Access Compliance Report Public Rights-of-Way (Pedestrian Signals)

Main Street: **BROOKHURST_ST** Cross Street: **CERRITOS_AVE** Location: **SE**

ADA ID: **SGAT220202142154** Signal Type: **One Push Button-Non APS** Overall Compliance: **No** Severity Scores: **BTN 1: 10** **BTN 2: N/A** **No BTN: N/A**

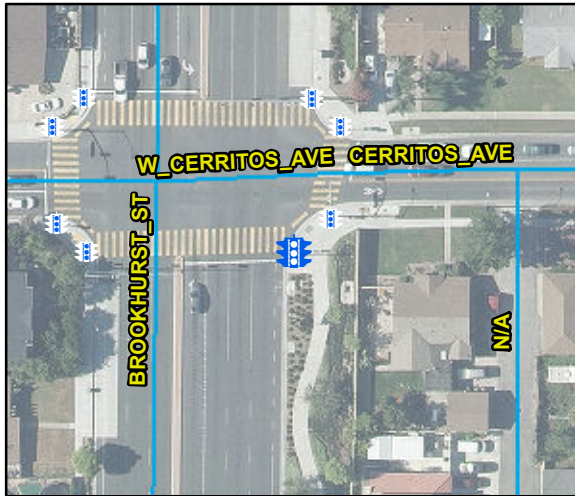
Possible Solutions: Replace Signal Push Button With APS Button.

OC Std/PROW: **MUTCD 4e.08**
